ISA CERTIFIED ARBORIST — PN-6981A
ISA TREE RISK ASSESSMENT QUALIFIED
American Society of Consulting Arborists, Member

Reference: Tree Protection Guidelines and Response to Corrections

Site Address: 9167 SE 64th, Mercer Island 98040

Attachment 4: Annotated Site Illustration – Updates to Site Plans Required

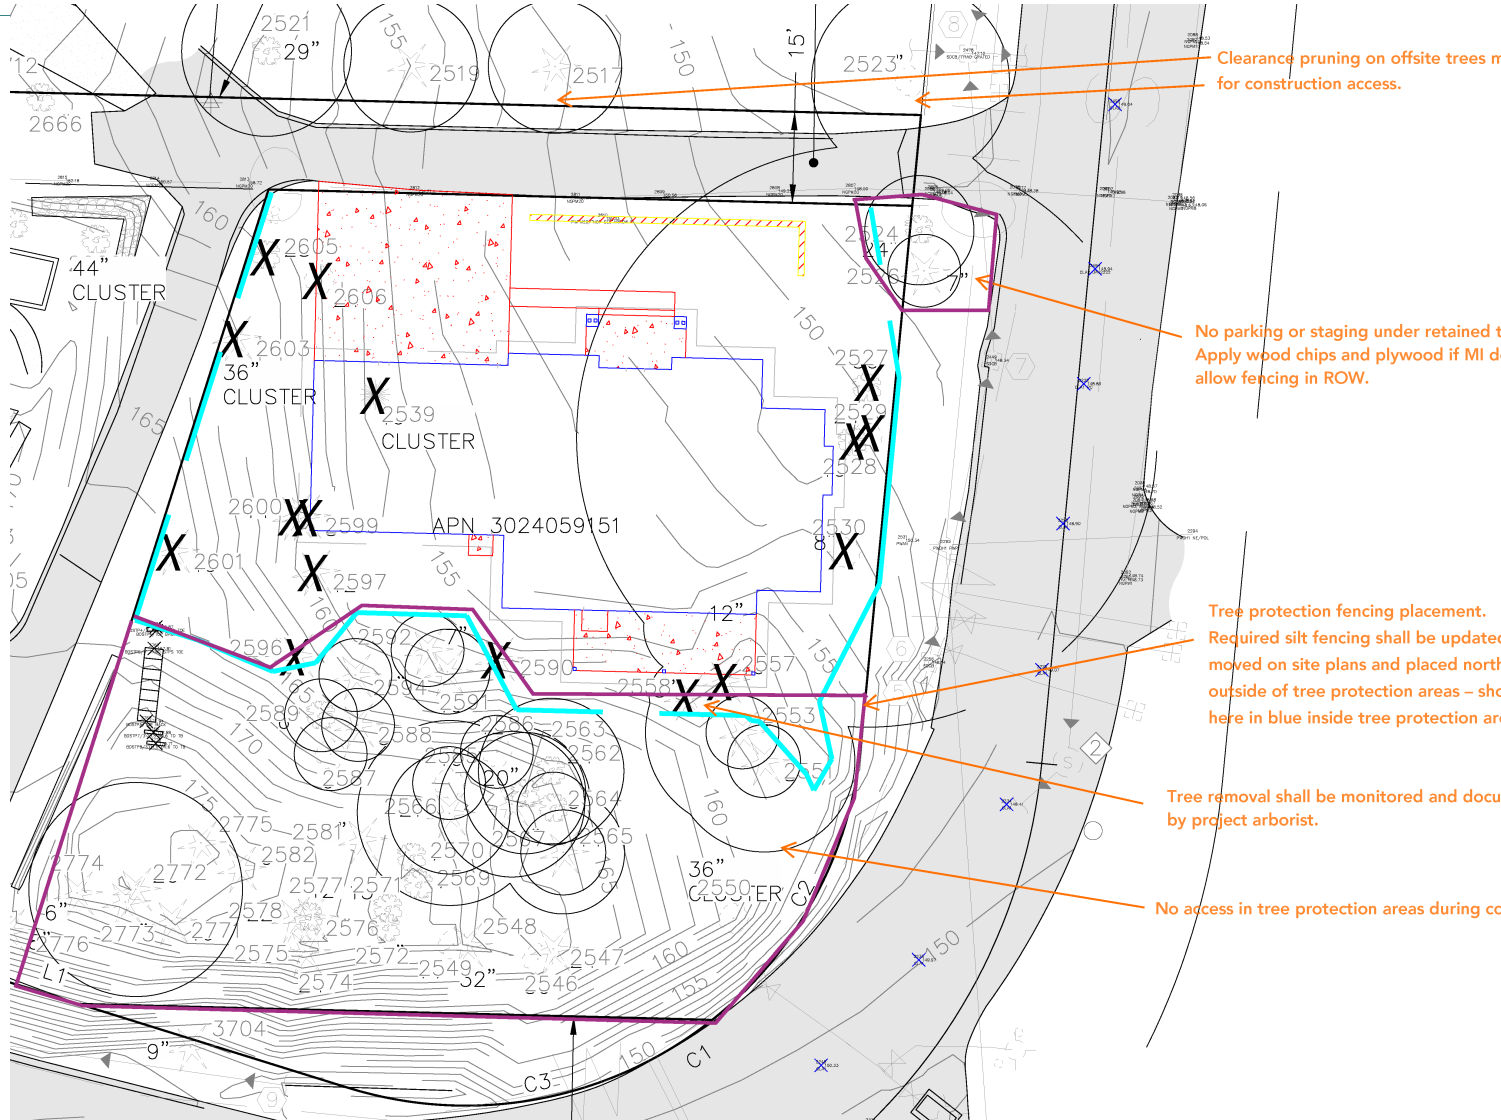
Clearance pruning on offsite trees may be required for construction access.

No parking or staging under retained trees. Apply wood chips and plywood if MI does not allow fencing in ROW.

Tree protection fencing placement. Required silt fencing shall be updated/moved on site plans and placed north or outside of tree protection areas – shown here in blue inside tree protection area.

Tree removal shall be monitored and documented by project arborist.

No access in tree protection areas during construction.
